RE: Longmont Distel Operations, File No. M-1989-029, Technical Revision (TR-05)
Response to Adequacy Review #1 Comments dated January 30, 2024.

The following discussion and attachments are submitted in response to Adequacy Review #1 comments prepared by the Division of Reclamation, Mining and Safety dated January 30, 2024 for the Longmont Distel Operations Technical Revision Request (TR-05).

6.0 EXHIBIT E – RECLAMATION PLAN

RECLAMATION PLAN
EXHIBIT F.1

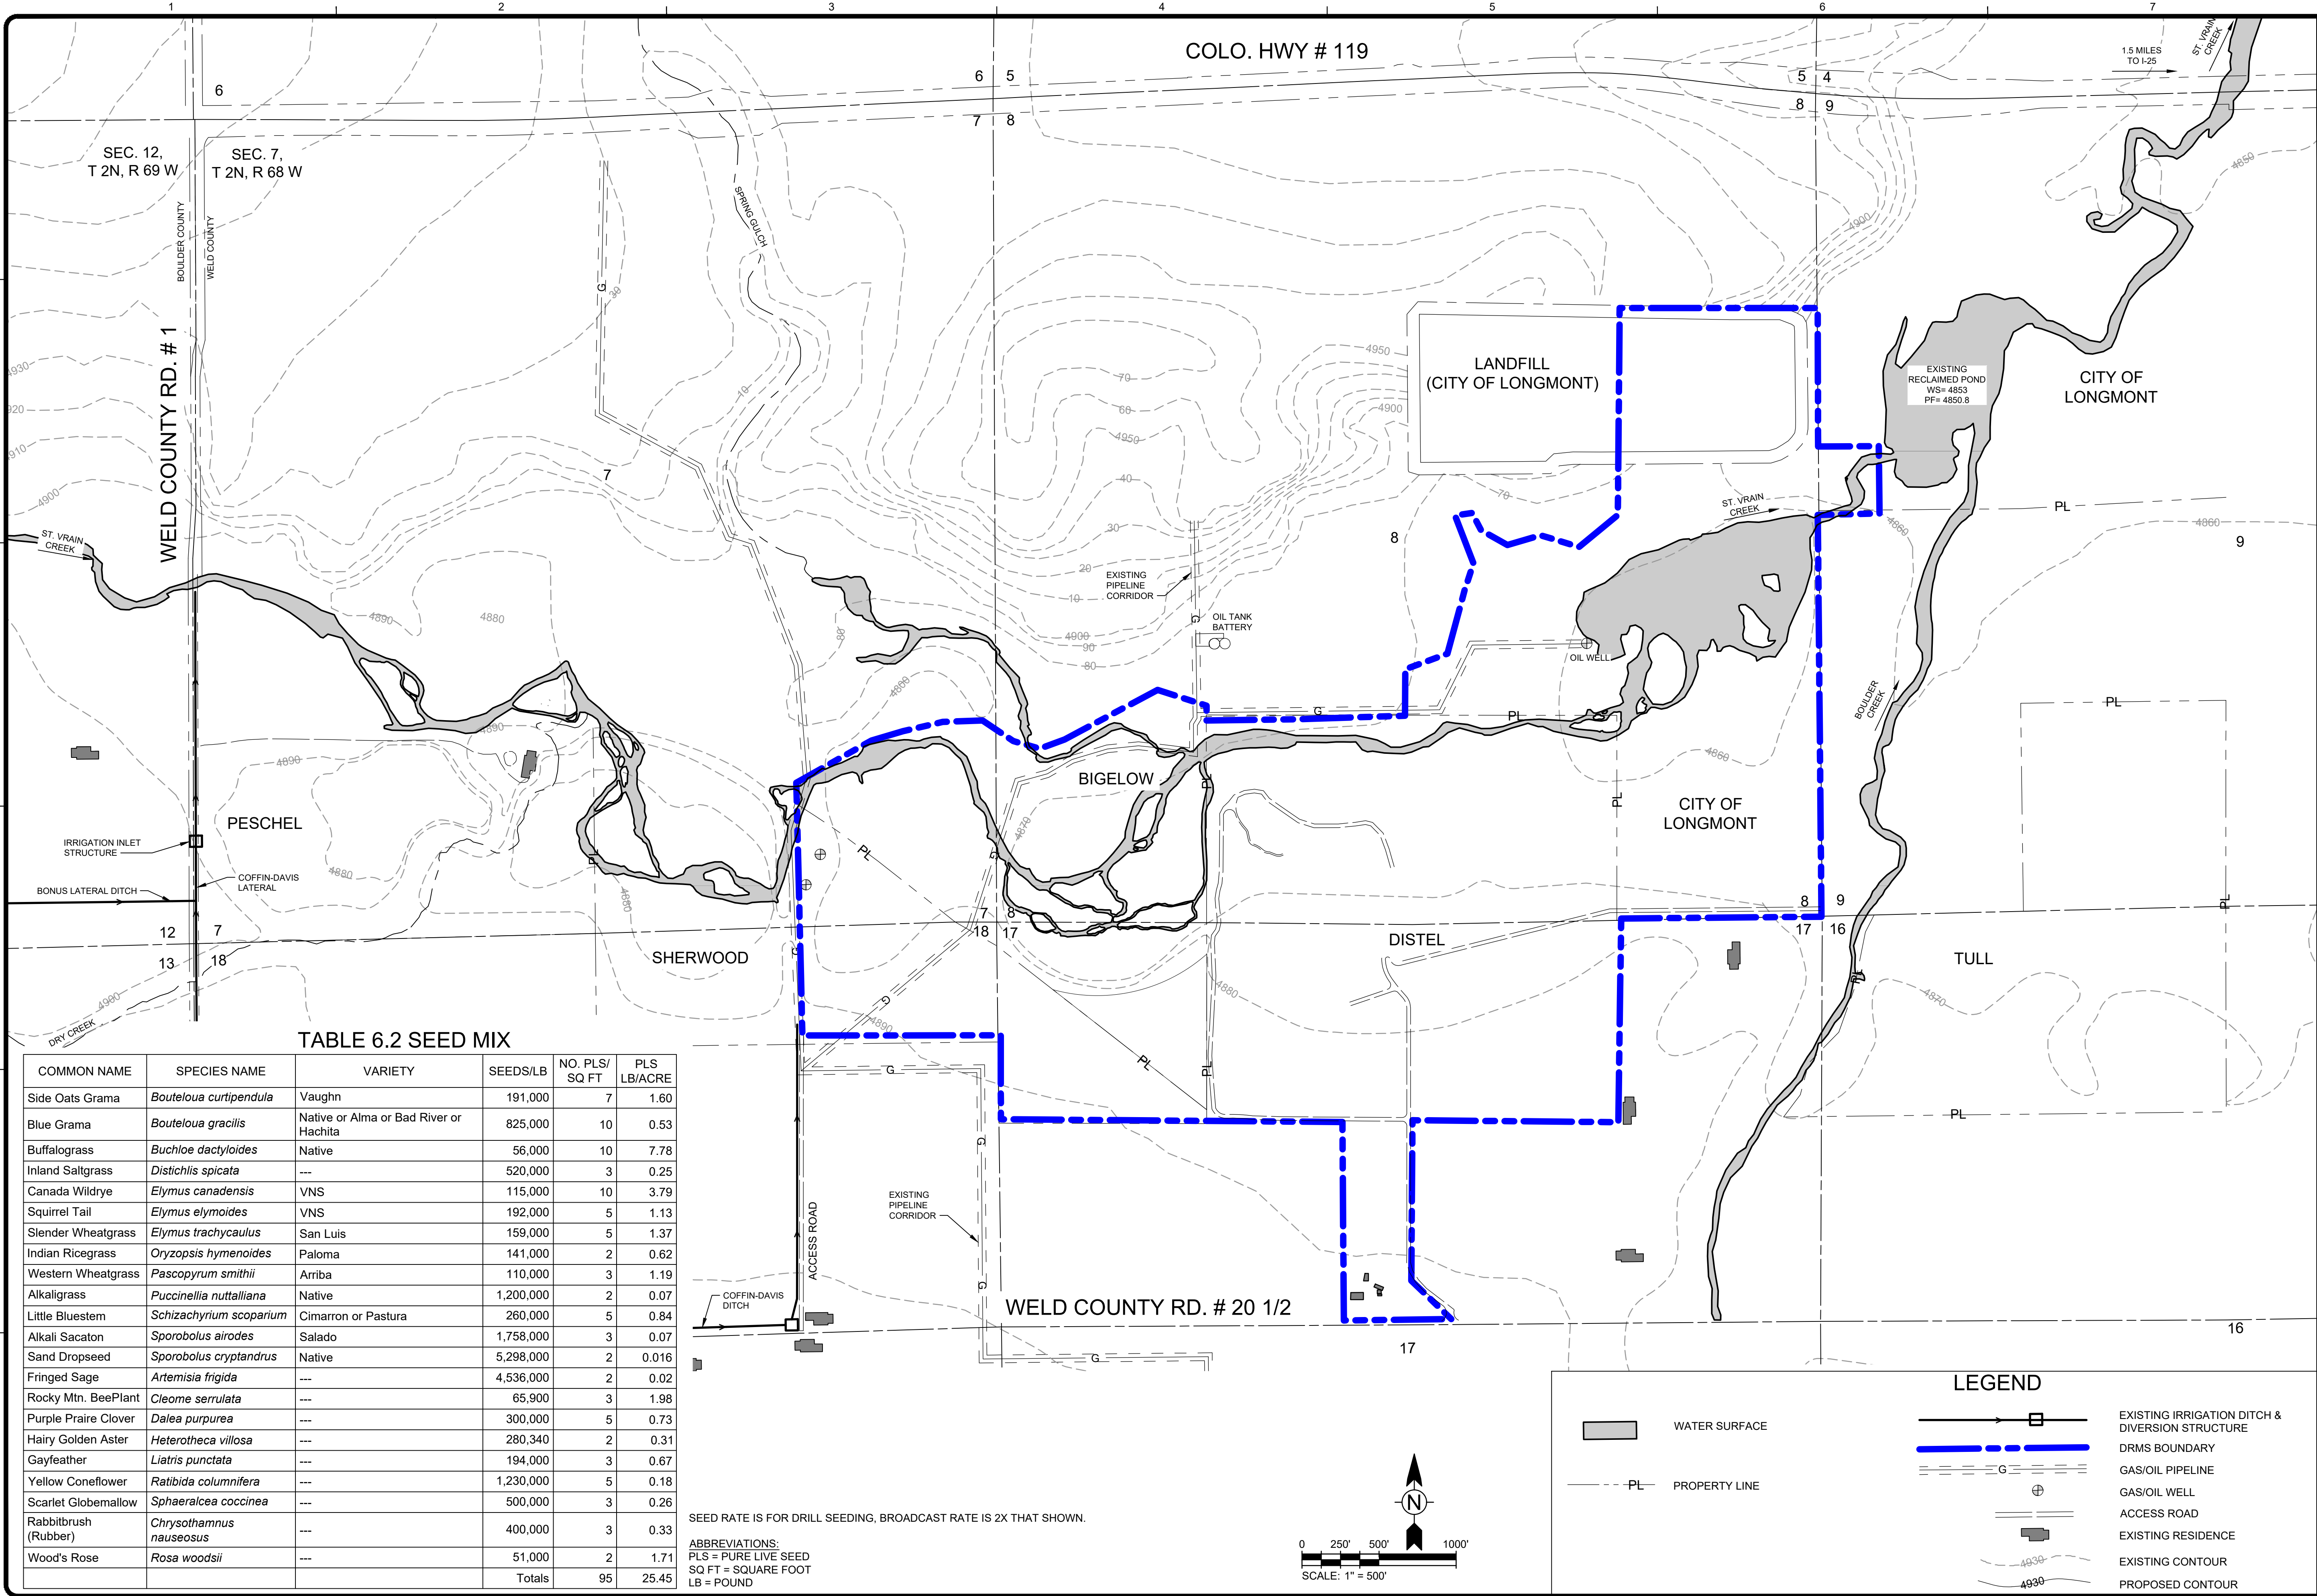
- 6.) Please submit an updated Exhibit F Reclamation Plan Map which reflects the proposed Reclamation Plan revisions, i.e. removal of ponds, no tree or shrub plantings, etc.

- Reference the attached revised Exhibit F.1 Reclamation Plan Map.
- 7.) Submit an updated Exhibit E, Reclamation Plan narrative which reflects the changes proposed in this TR request. What is the proposed type of replacement vegetation and ecologic environment for areas previously planned to be wetlands and ponds? If there are any proposed changes to the currently approved seed mix, please submit this information as well.

The remainder of the currently disturbed areas, approximately 164 acres, will be reclaimed as upland meadows. The proposed layout of the upland meadows is illustrated in the revised Exhibit F.1. Reclamation topography will be dependent on post-mining activities and may vary.

Tree planting, shrub planting, ponds, and wetland creation will not occur as called out in Amendment 3. All remaining disturbance areas will be seeded with current upland seed mixture identified in Table 6.2.

RECLAMATION PLAN
EXHIBIT F.1

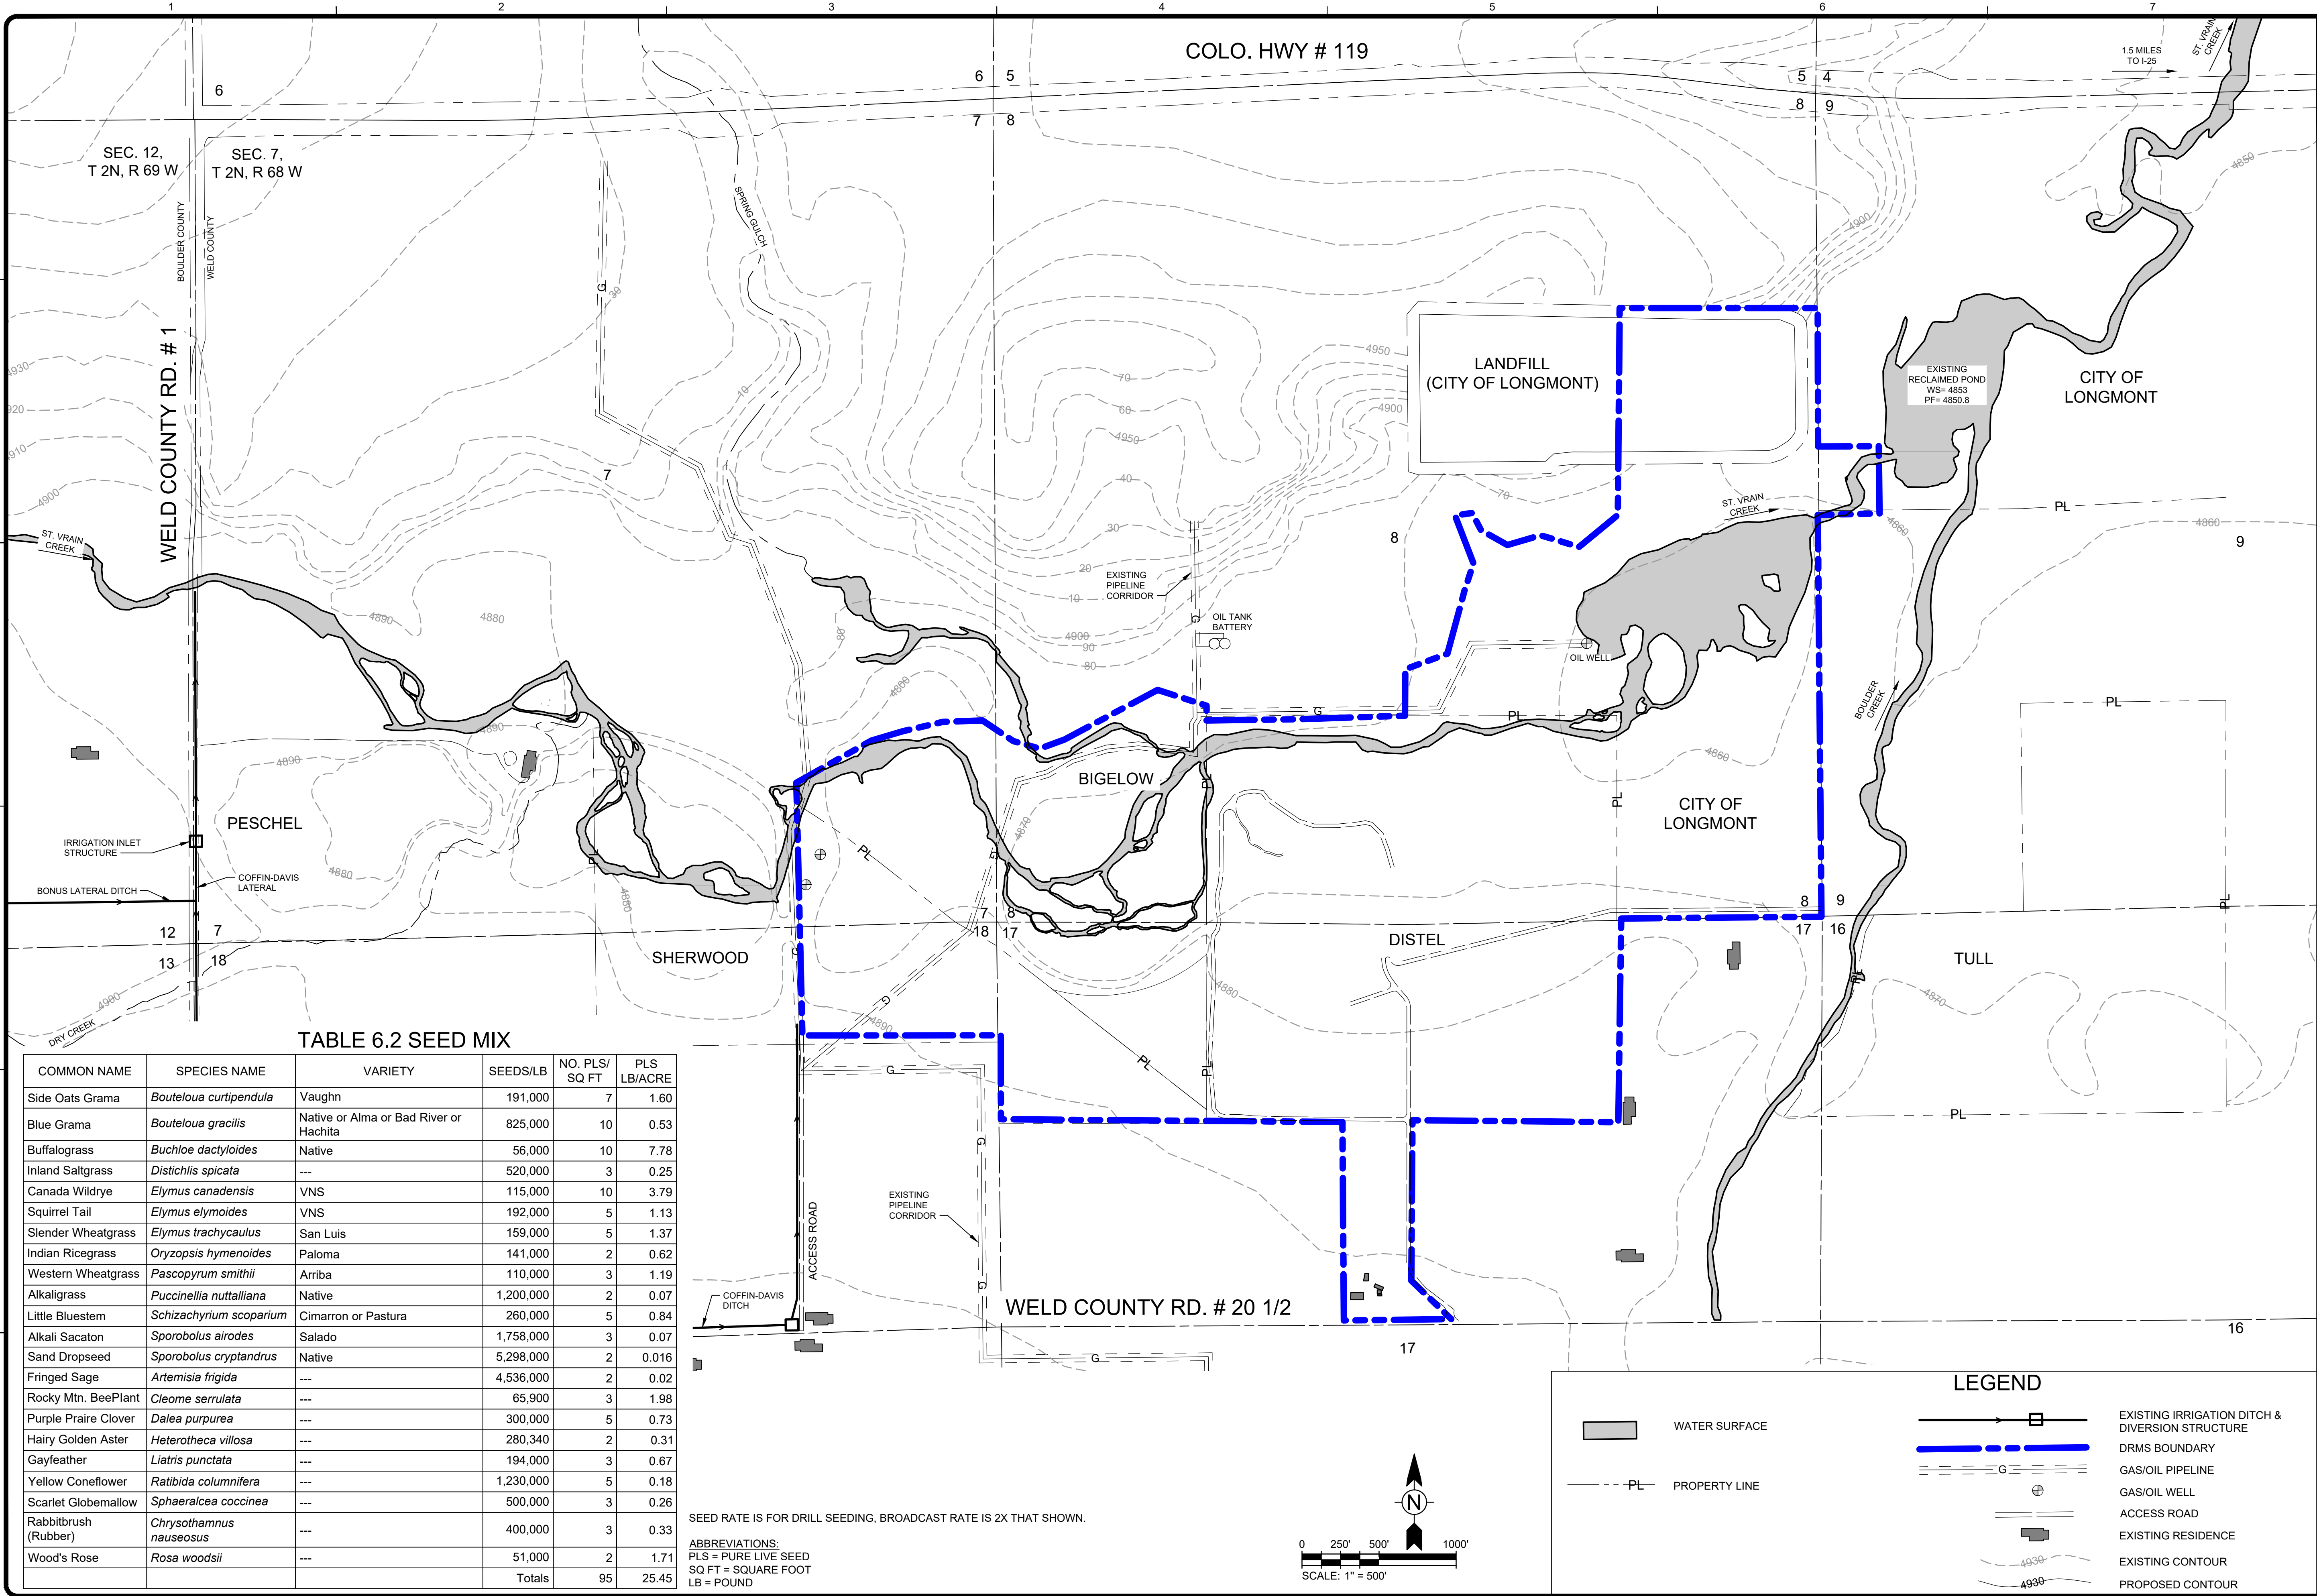
- 6.) Please submit an updated Exhibit F Reclamation Plan Map which reflects the proposed Reclamation Plan revisions, i.e. removal of ponds, no tree or shrub plantings, etc.

- Reference the attached revised Exhibit F.1 Reclamation Plan Map.
- 7.) Submit an updated Exhibit E, Reclamation Plan narrative which reflects the changes proposed in this TR request. What is the proposed type of replacement vegetation and ecologic environment for areas previously planned to be wetlands and ponds? If there are any proposed changes to the currently approved seed mix, please submit this information as well.

The remainder of the currently disturbed areas, approximately 164 acres, will be reclaimed as upland meadows. The proposed layout of the upland meadows is illustrated in the revised Exhibit F.1. Reclamation topography will be dependent on post-mining activities and may vary.

Tree planting, shrub planting, ponds, and wetland creation will not occur as called out in Amendment 3. All remaining disturbance areas will be seeded with current upland seed mixture identified in Table 6.2.
